Access Compliance Report Public Rights-of-Way (Pedestrian Signals)

Main Street: COW_CAMP_RD Cross Street: CHIQUITA_CANYON_DR Location: NW

ADA ID: SGRK211124121853 Signal Type: One Push Button-Non APS Overall Compliance: No Severity Scores: BTN 1: 25 BTN 2: N/A No BTN: N/A

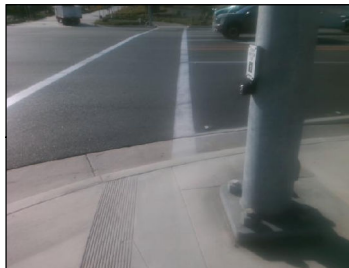
OC Std/PROW: R404.2, R404.3

Possible Solutions: Remove and Replace Clear Space.
